STAFF REPORT: SEPTEMBER 13, 2023 MEETING

APPLICATION NUMBER: 22-7665

ADDRESS: 715 VAN DYKE

SCOPE: ALTERATIONS TO PREVIOUSLY APPROVED PORCH DESIGN (WORK COMPLETED WITHOUT APPROVAL)

Vol. 8, 1910, Image 7

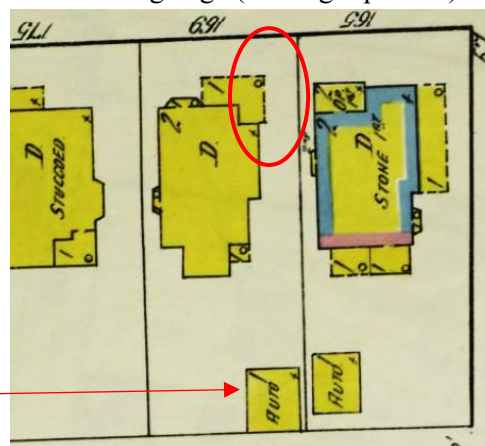
- The West Village Historic District was established in 1983.
- Per the below Sanborn maps, between 1910 and 1915 the southern end of the front porch was reduced in size for the introduction of a driveway which led to a detached garage (no longer present).

HDC staff photo, August 30, 2023. Full columns were installed in place of reinstalling historic pilasters. Photos of pilasters in their original locations are on the following page.

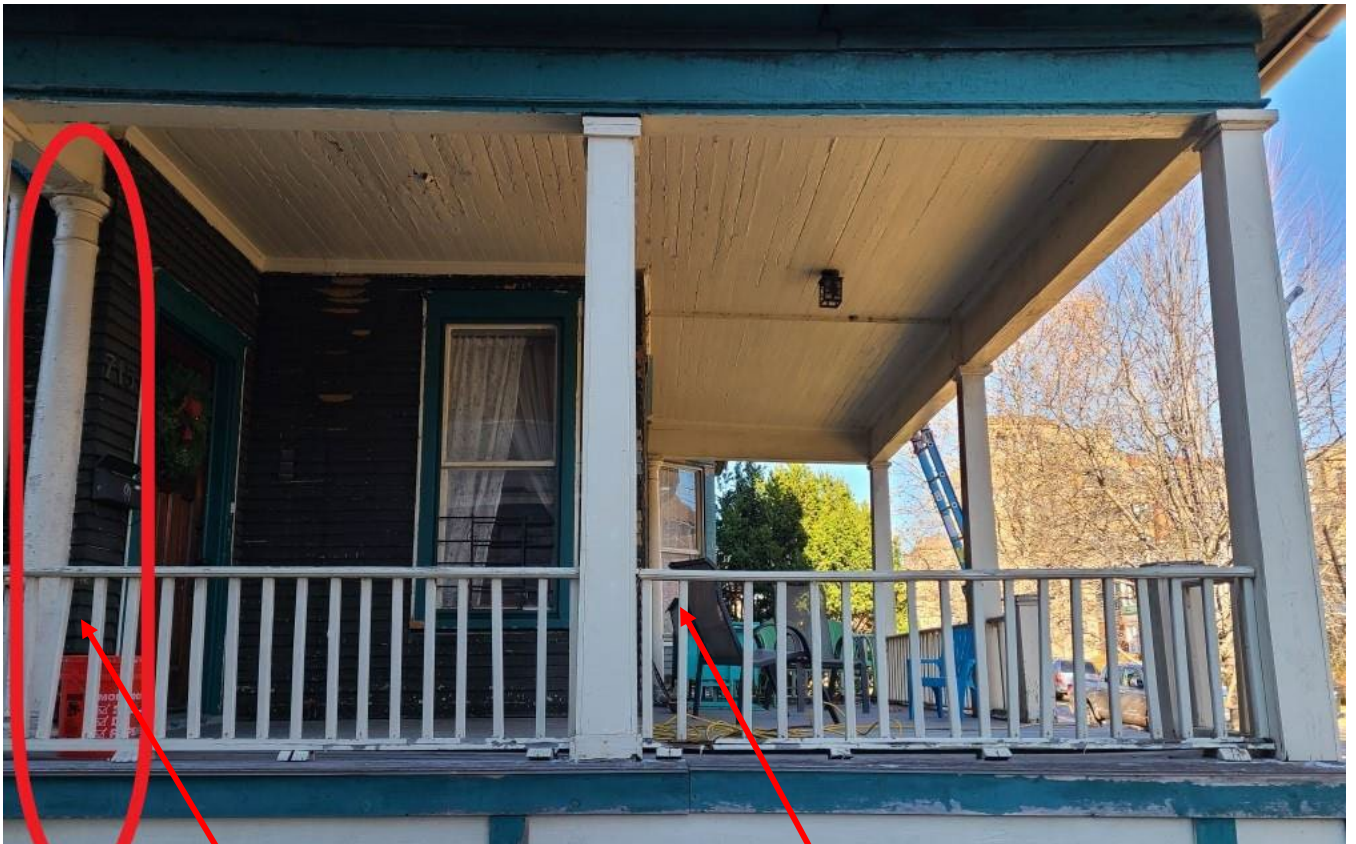
- The historic pilasters were replaced with round columns. Additionally, taller turned spindles were used for the porch railing, thick square newel posts were used at the stairs and a "solid" (i.e., no cut-outs) skirting with diamond medallions was installed.

- Based on the photographs provided by the applicant within the February 2022 application, the wood pilasters remained on site and appeared to be solid and not deteriorated beyond repair.

- When the applicant determined the pilasters couldn't be reinstalled, due to a reported conflict with placement against the wood siding, the HDC should have been contacted to allow staff to inspect the existing conditions before replacement of the historic pilasters was considered.

- It is staff’s opinion the installed porch columns don’t meet the threshold of reasonable and feasible. The historic pilasters were the remaining distinctive, character-defining feature of the front porch and were to be reinstalled in their historic/original location. Composite Tuscan columns, similar in design and dimension to the historic pilasters as shown on the submitted cut sheet from the February 2022 application, are likely readily available. New Tuscan columns could have closely matched the historic pilasters and not offered a “piecing together of the porch appearance” as stated by the applicant. The current columns are much simpler in design and proportion and removed a level of architectural and historic detailing from the dwelling.

Recommendation One – Denial – Porch columns and medallions

Staff finds that the application of diamond-shaped medallions to the porch skirting, the removal of the historic pilasters, and the full-scale installation of minimally detailed porch columns do not meet the Secretary of the Interior’s Standards for the following reasons:

- The historic wood pilasters were distinctive character-defining features in design, materiality and placement (i.e. attached to the house’s exterior walls).
 - Documentation was not submitted to staff showing significant deterioration and/or the inability for reinstallation.
 - The minimally detailed columns do not closely emulate the Tuscan-styling of the historic half-round pilasters, and no confirmation was submitted to staff to show that the previously approved column was not commercially available.
- The medallions applied to the porch skirting do not mimic historic decorative openings that allowed for ventilation to the underside of a porch.

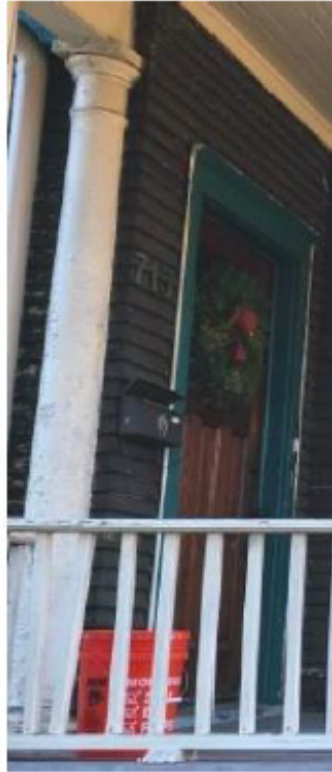
- The best and most appropriate replacement would be a turned-wood column to match the existing prototype. However, it is staff’s opinion the replacement column, while not a perfect match, is similar to the design and proportionality of the historic column and therefore, is reasonable and feasible.

Photo and catalog images supplied by applicant.
The original pilaster appears to have a slightly tapered smooth shaft.
The proposed fiberglass column has a similar Tuscan capital (with slightly different dimensions) and a smooth tapered shaft. The diameter at its widest point will be 8”, similar to the wood pilaster’s width.

- The applicant submitted photographs of the pilasters noting most of the measurements, however the angle of the camera to the measuring tape that was near the pilaster shaft, made the measurements confusing to read. The applicant submitted the additional photos listed below showing the tapered column ranges from 7” – 8” in diameter.
